INCH-POUND
MIL-PRF-55182/9F
AMENDMENT 3
14 February 2002
SUPERSEDING
AMENDMENT 2
14 June 2001

RESISTORS, FIXED, FILM, NONESTABLISHED RELIABILITY,
ESTABLISHED RELIABILITY, AND SPACE LEVEL, STYLE RNC90

This amendment forms a part of MIL-PRF-55182/9F, dated 9 June 97, and is approved for use by all Departments and Agencies of the Department of Defense.

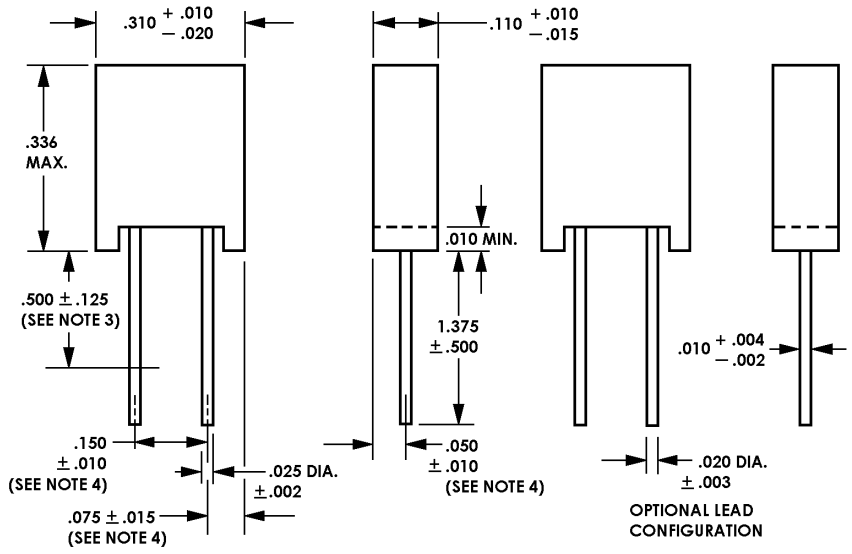
3.5, delete and substitute.

"3.5 Voltage rating. The maximum continuous working voltage shall not exceed 300 volts."

FIGURE 1. Style RNC90 resistor. 2/

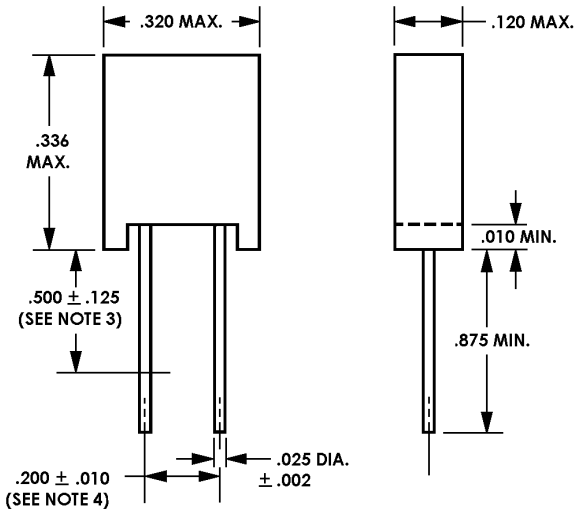
Delete figure 1 in its entirety and substitute new figure 1 below:

Configuration A

Configuration B

NOTES:
1. Dimensions are in inches.
2. Metric equivalents are given for general information only
3. Resistance measurement point
4. The lead measurements shall be made at the point of emergence for the body.
5. Style of standoffs optional
